WASHINGTON PUBLIC POWER SUPPLY SYSTEM

MAY 1981

WNP-2

Figure 4.6-5a

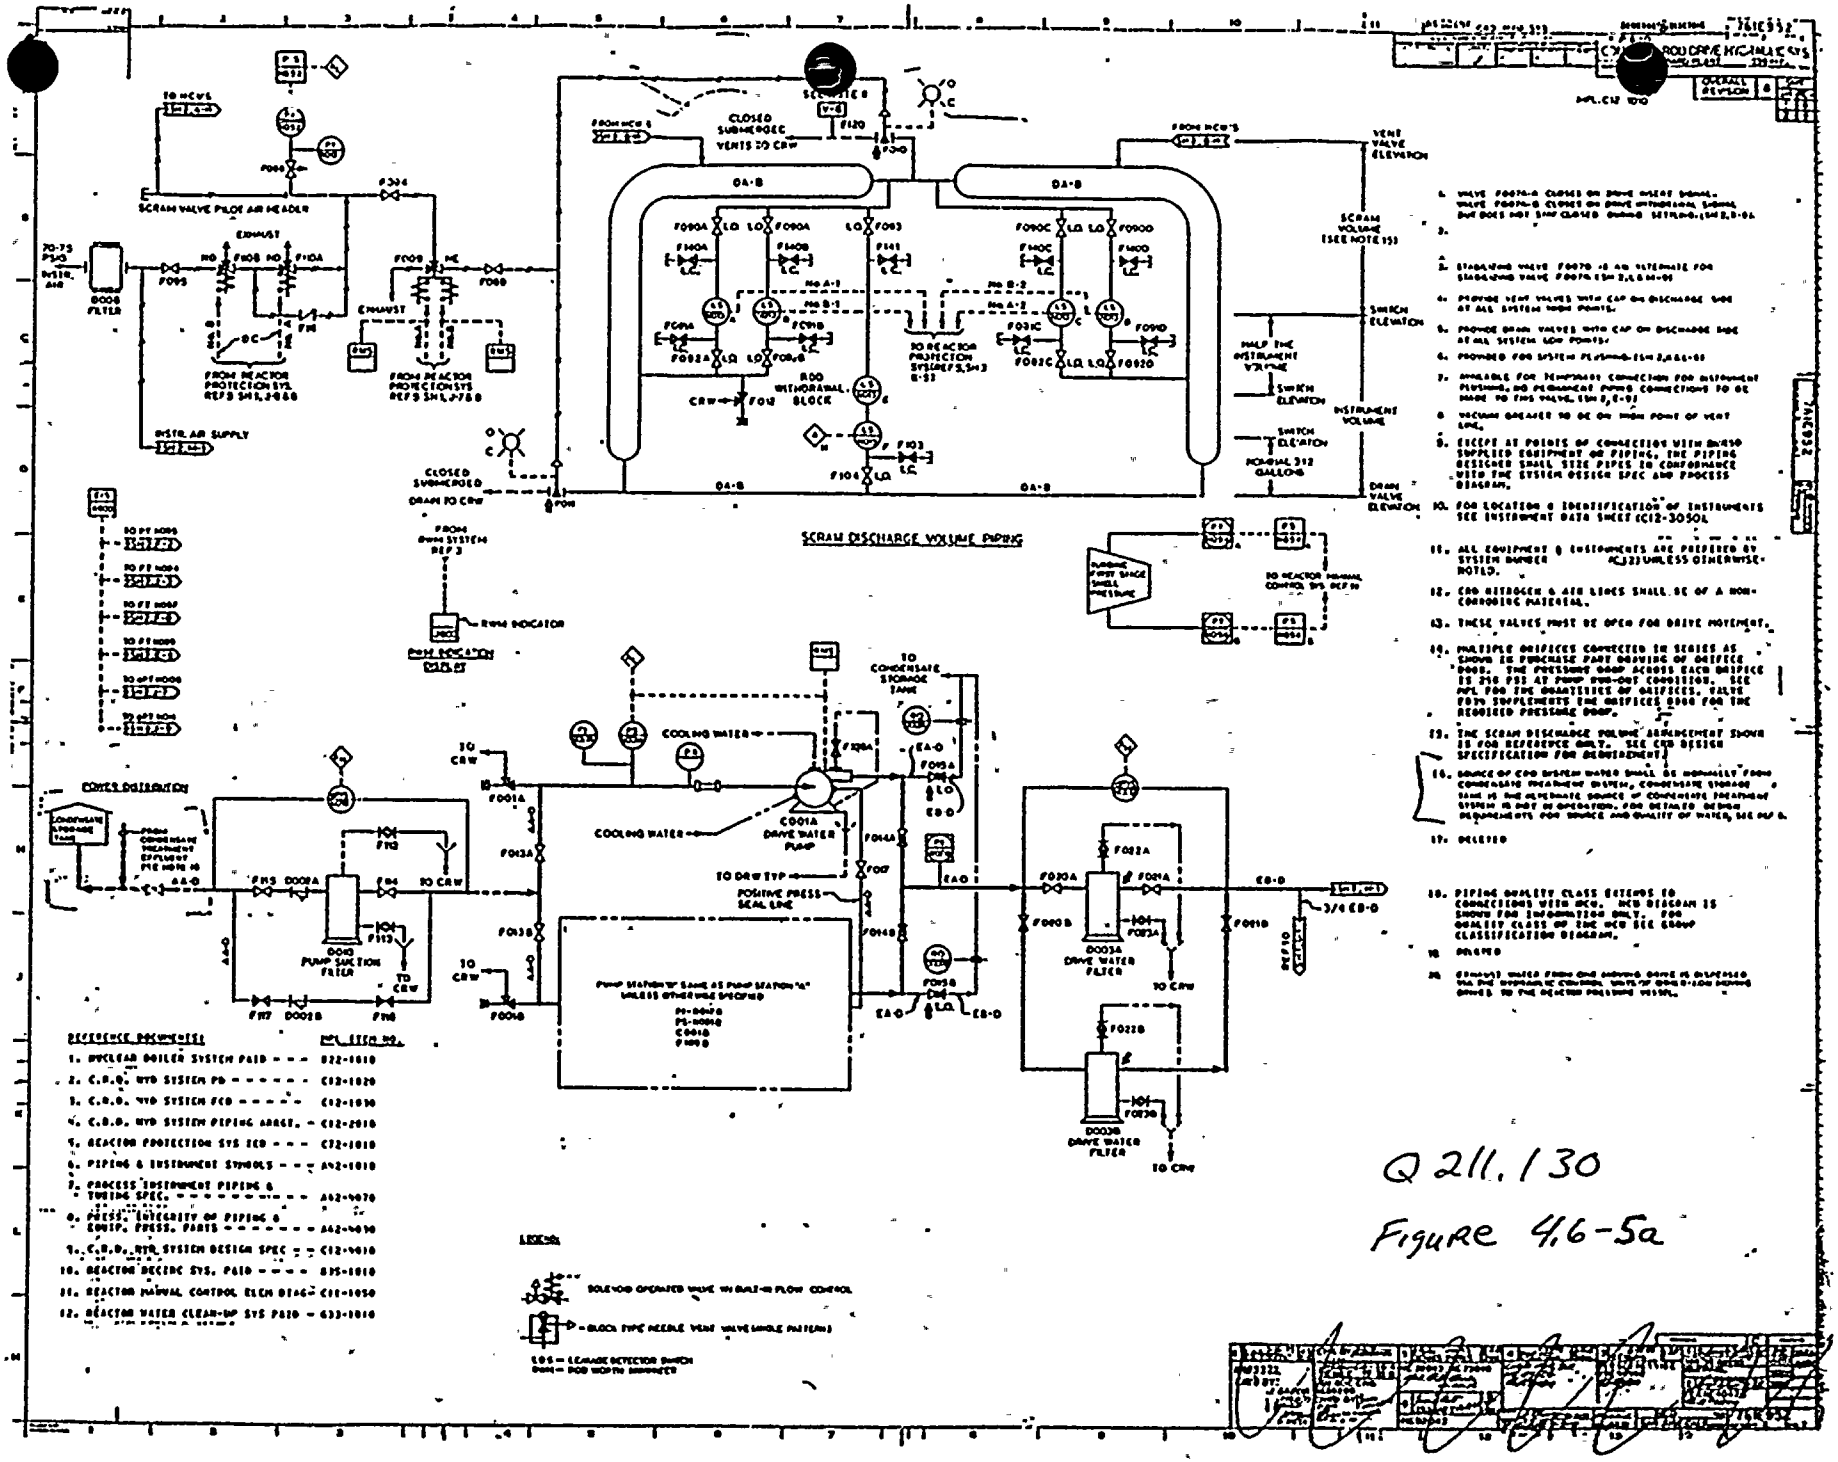
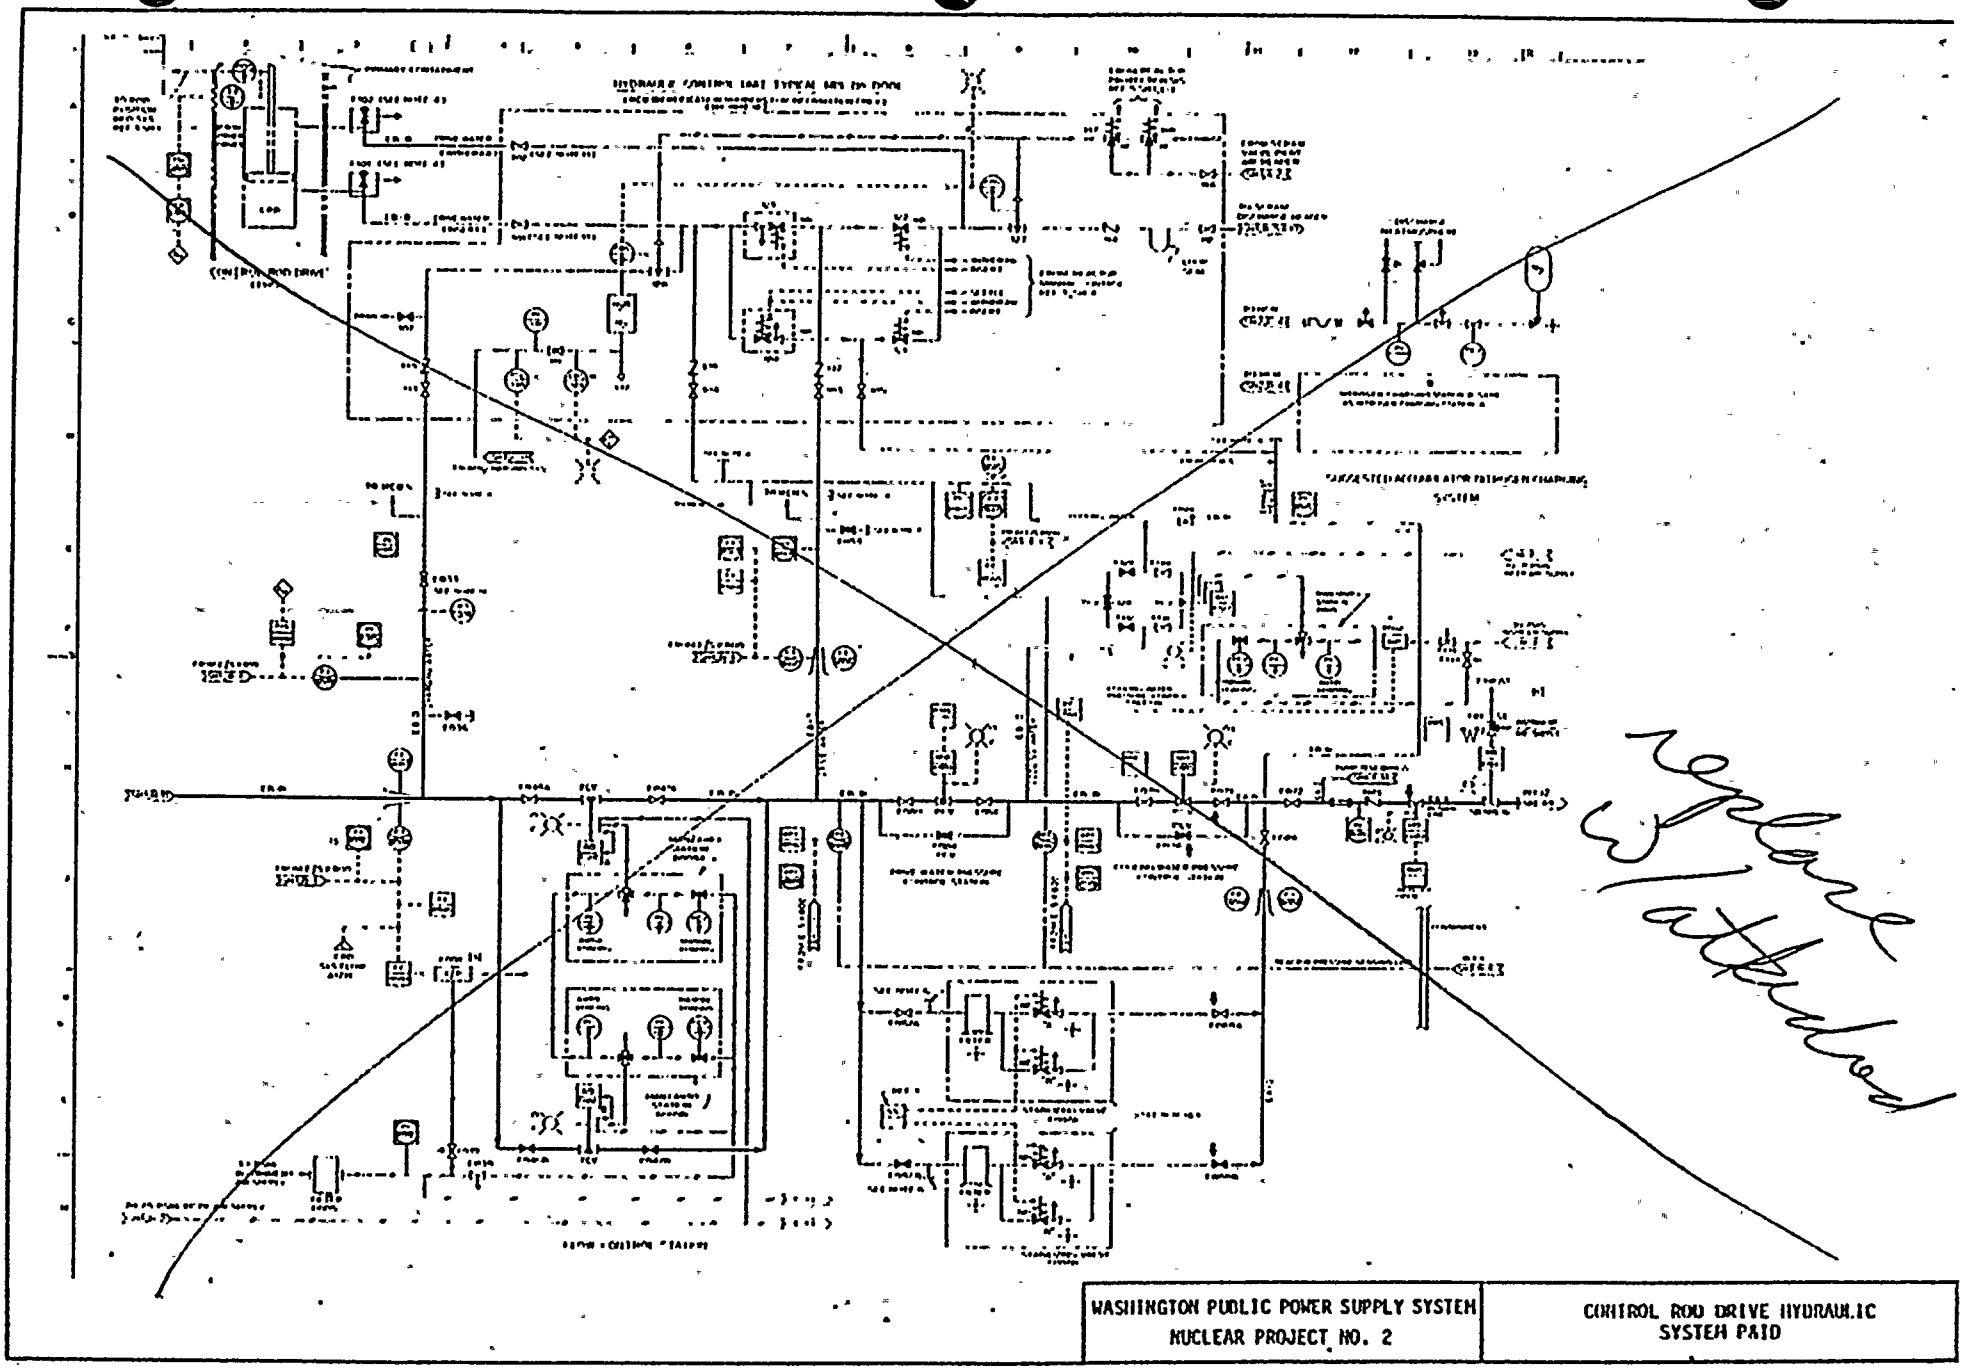
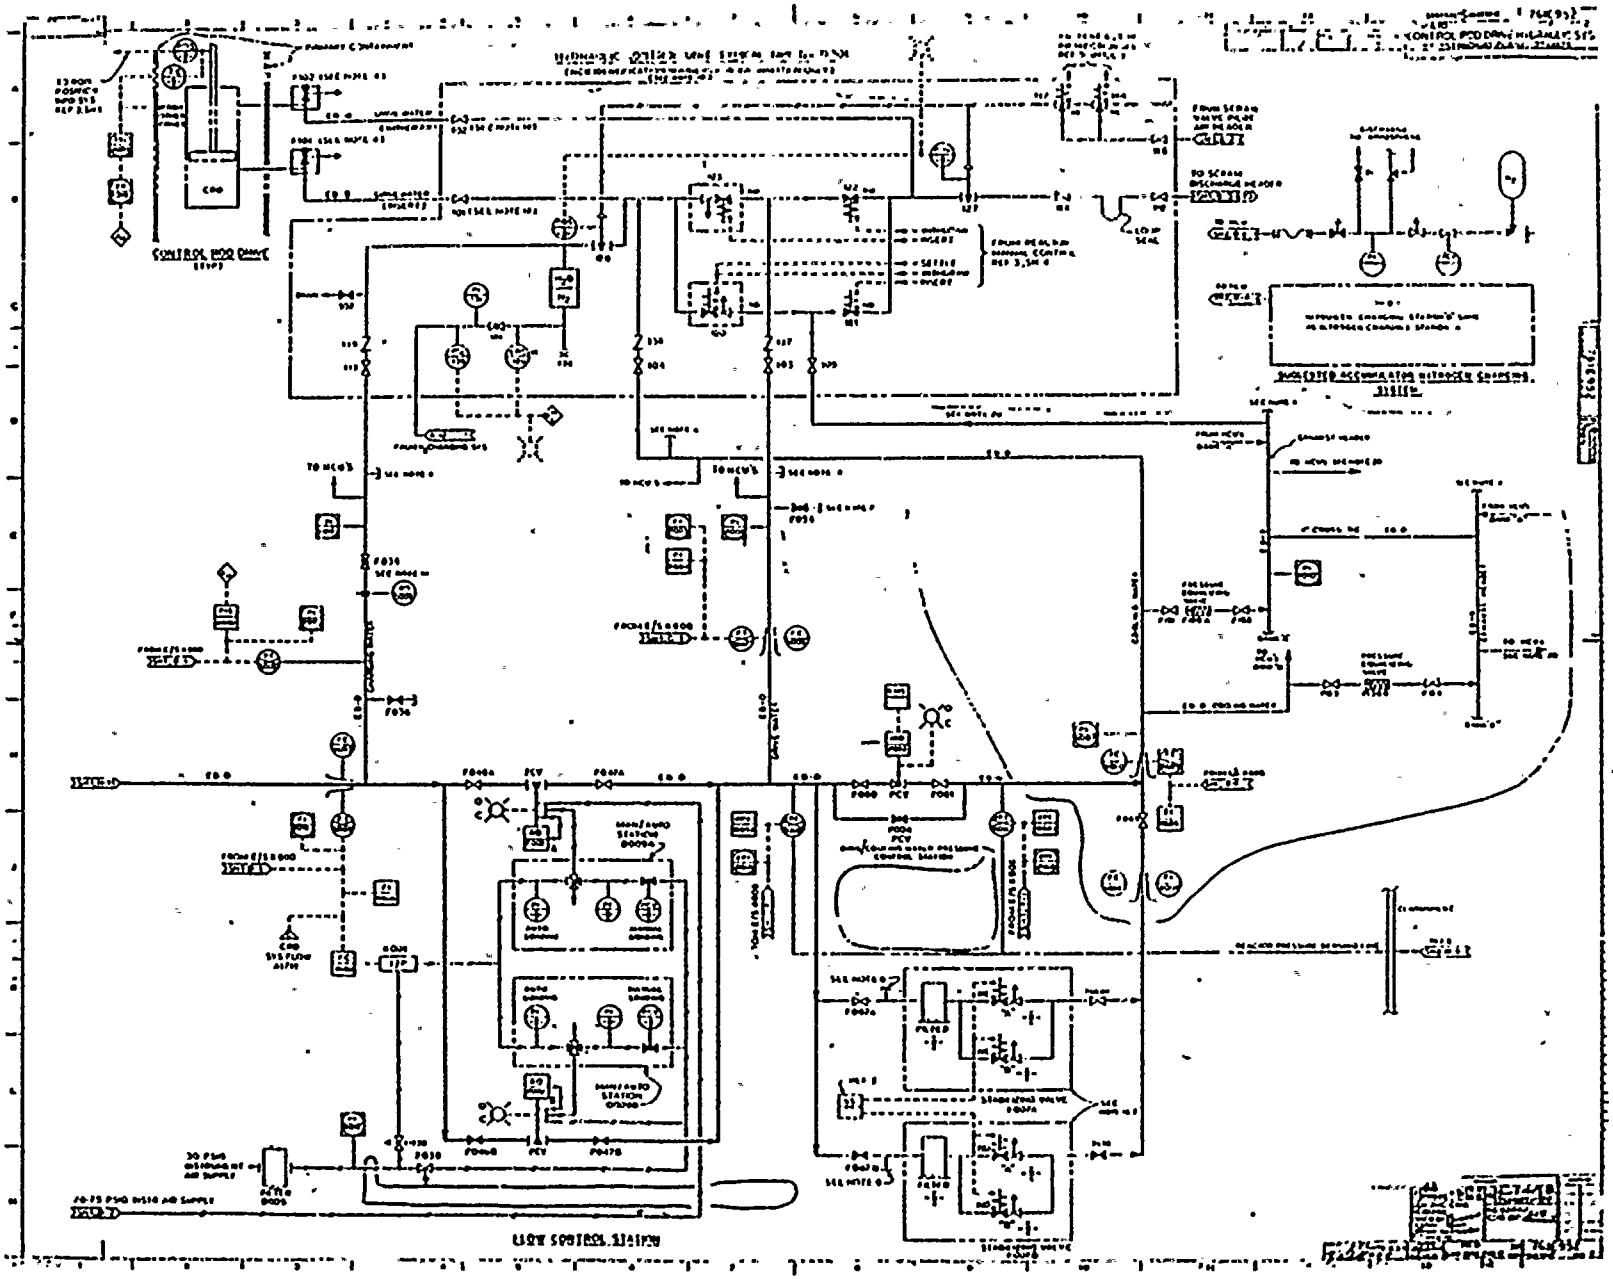
Table 1.3-8 indicates specific design changes from the PSAR to the FSAR for the CRD system. The design changes for the CRD return line modification addressed in Question 211.019, have not been included in the text description of the FSAR and Figures 4.6-5a, 4.6-5b, and 4.6-6a have not been revised. Revise the text description in the FSAR to reflect the specific design changes in Table 1.3-8 for the CRD system and modify the above figures accordingly.

Revised FSAR Figure 4.6-5b (Amendment 16) does not appear to show valves F129, F130, F131, and F132. The applicant should explain if this is what is meant in the response by "removing the discrepancy identified above". In addition, the revised FSAR page was not provided as stated in the response. The applicant should provide the revised FSAR page and describe the revision.

The text description of the scram accumulator indicates that a check valve in the accumulator charging line prevents loss of water pressure in the event supply pressure is lost. The symbol for valve 111 in Figure 4.6-5b and Drawing M528 appears to be that of a normally open globe valve instead of a stop-check globe valve. Explain this apparent discrepancy.

Figures 4.6-5a, 4.6-5b, 4.6-6a, 4.6-6b, and 4.6-6c are revised to reflect the CRD return line modification. Figures 4.6-6d and 4.6-6e are deleted. Also, text sections 4.6.1.1.2.4, 4.6.1.1.2.4.1, 4.6.1.1.2.4.2.3, 4.6.1.1.2.4.2.4 and 4.6.2.3.2.2.8 are revised accordingly. Text section 4.6.1.1.2.4.2.5 is deleted.*

FSAR Figure 4.6-5b (Amendment 16) does not show valves F129, F130, F131, and F132 because these valves were removed from the CRD system when the CRD return line to the RPV was eliminated.

What is meant by "removing the discrepancy identified above" in the response to Question 211.134 (later changed to 010.047) is that by submitting revised FSAR Figure 4.6-5b the discrepancy identified in Question 010.047 between the FSAR text, M528 (FSAR 3.2-4) and FSAR Figure 4.6-5b was resolved.

There is no disagreement between 4.6.1.1.2.4.3.9 of the FSAR text and Figure 4.6-5b and Drawing M528 concerning valve 111. "A check valve in the accumulator charging line prevents loss of water pressure in the event the supply pressure is lost" refers to valve 115 and to the "charging water". Valve 111 is closed only when the pressure instrumentation is being serviced and when the nitrogen charging station is being connected and disconnected.*
